Z-63
(2016)

BALFOUR PLACE
1668 JOHNSON FERRY RD
MARIETTA, COB 30067
REZONING SITE PLAN

Z-1.0

ZONING COMMENTS:

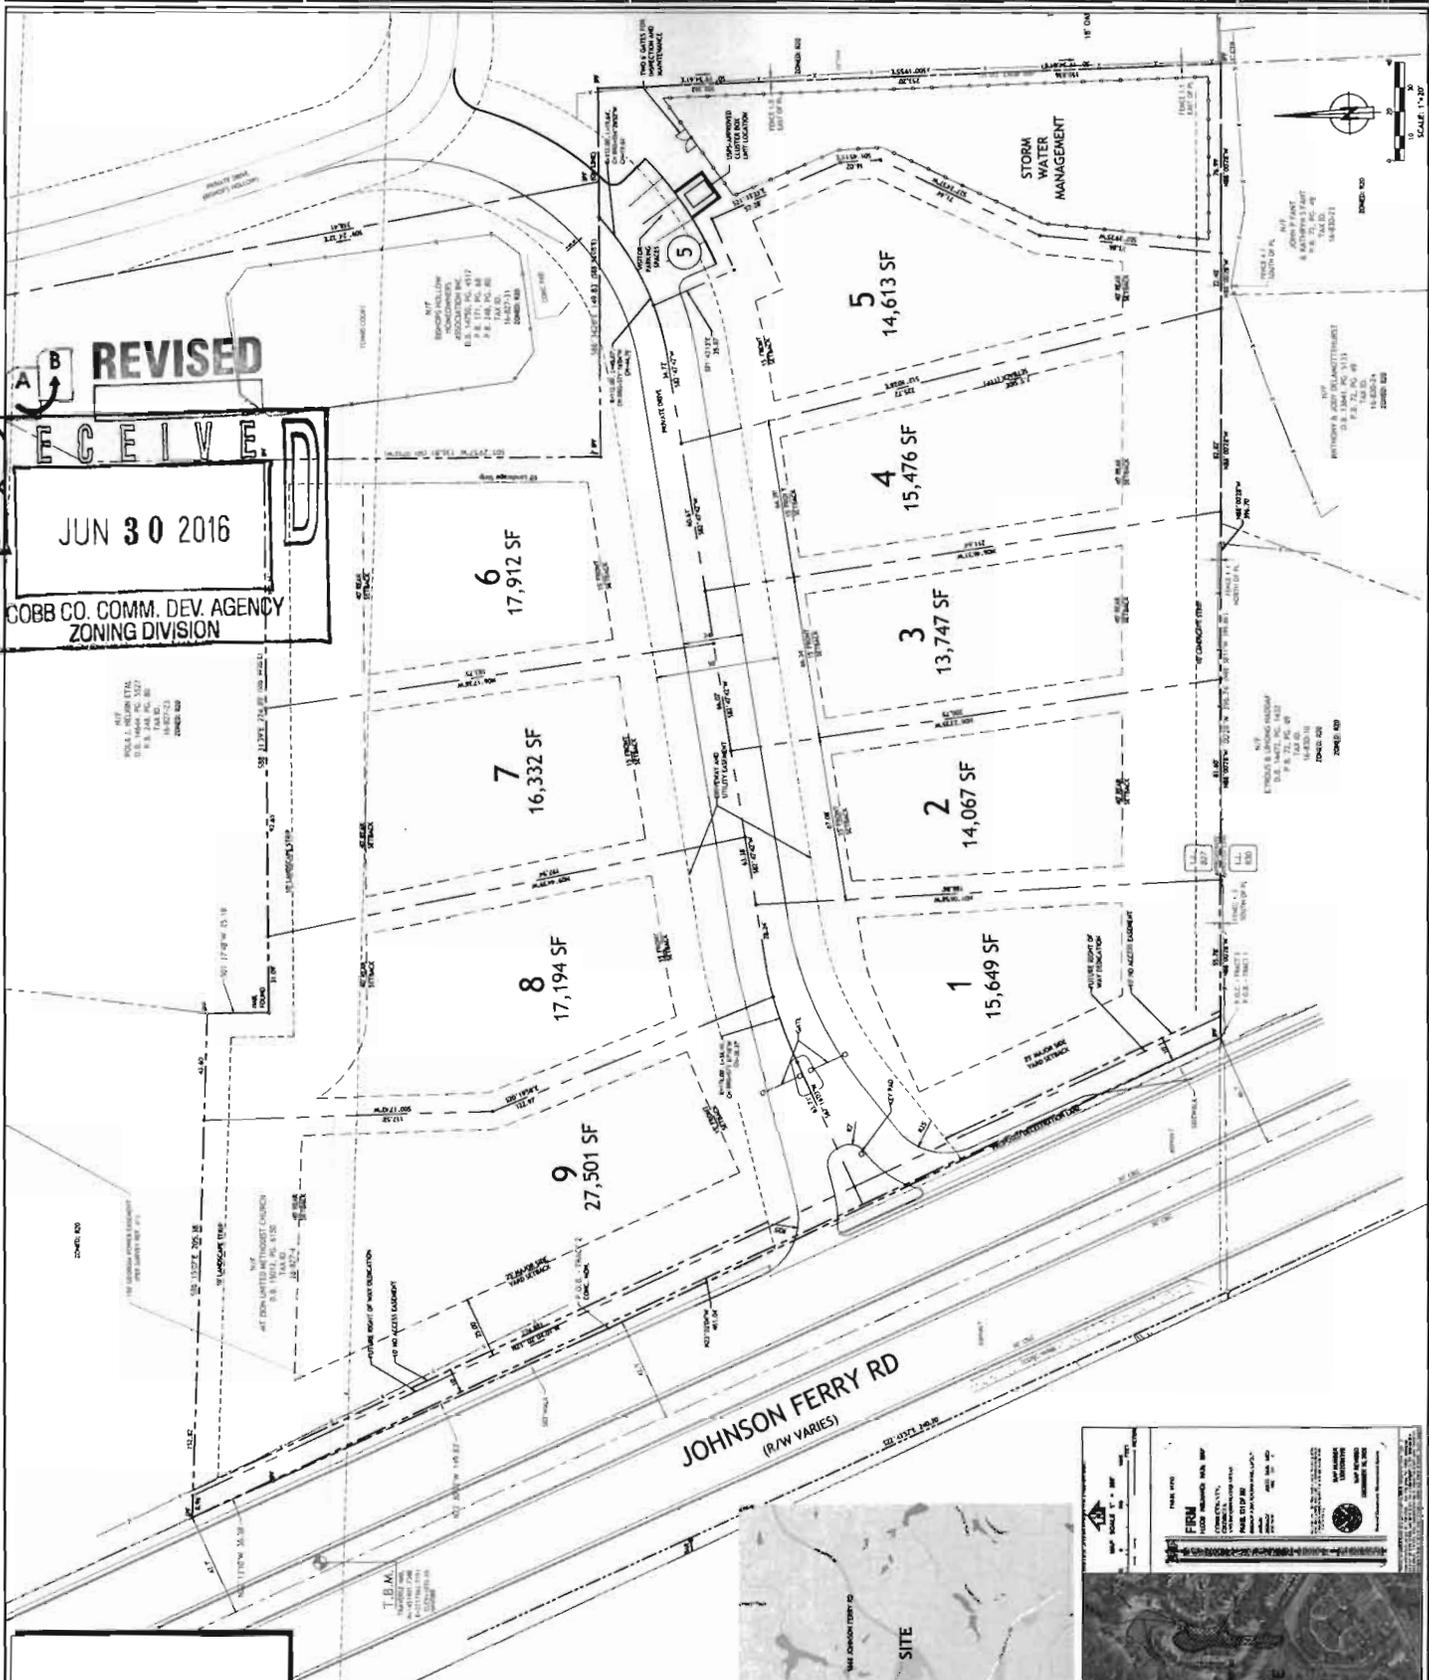
As was previously approved, the currently proposed layout requests a reduction in the minimum lot widths from the required 75 feet to 60 feet at the front setback line while a complete waiver of the required public road frontage is necessary due to now being a private drive within the subdivision rather than the previously approved public right of way.

If this rezoning request is approved, the final subdivision plat for Bishop's Hollow must be revised so as to show the new configuration, along with an access easement across 1764 Bishop Lake Ct. The surveyor must submit the plat to the Site Plan Review Section, Community Development Agency for review and approval prior to recording. Call 770-528-2147.

- Guest Parking be implemented to facilitate clear roadways for emergency vehicle response

Additional Comments: CCWS will need regular access behind gate to read water meters

- Provide comprehensive hydrology/stormwater controls to include development of out parcels.
- Submit all proposed site improvements to Plan Review.
- Any **spring activity** uncovered must be addressed by a qualified geotechnical engineer (PE).
- Structural fill _____ must be placed under the direction of a qualified registered Georgia geotechnical engineer (PE).
- Existing facility.
- Project must comply with the Water Quality requirements of the CWA-NPDES-NPS Permit and County Water Quality Ordinance.
- Water Quality/Quantity contributions of the existing lake/pond on site must be continued as baseline conditions into proposed project.
- Calculate and provide % impervious of project site.
- Revisit design; reduce pavement area to reduce runoff and pollution.

- No Stormwater controls shown _____
- Copy of survey is not current – Additional comments may be forthcoming when current site conditions are exposed.
- No site improvements showing on exhibit.

Recommend applicant consider entering into a development agreement pursuant to O.C.G.A. 36-71-13 for dedication of the following system improvements to mitigate traffic concerns: a) donation of right-of-way on the east side of Johnson Ferry Road, a minimum of 50' from the roadway centerline.

Recommend curb and gutter along both sides and sidewalk along one side of proposed development roadway.

Recommend a deceleration lane on Johnson Ferry Road for the entrance.

Recommend restricting the Johnson Ferry Road driveway to right in/right out.

Recommend the proposed gate to be located at least 50' from right-of-way and meet Cobb County Development Standards.

Recommend a no access easement along the lots that border Johnson Ferry Road.

1. Site plan received by the Zoning Division on June 1, 2016, with the District Commissioner approving minor modifications;
2. Water and Sewer Division comments and recommendations;
3. Stormwater Management Division comments and recommendations;
4. Fire Department comments and recommendations;
5. Department of Transportation comments and recommendations; and
6. Owner/developer to enter into a Development Agreement pursuant to O.C.G.A. §36-71-13 for dedication of system improvements to mitigate traffic concerns.
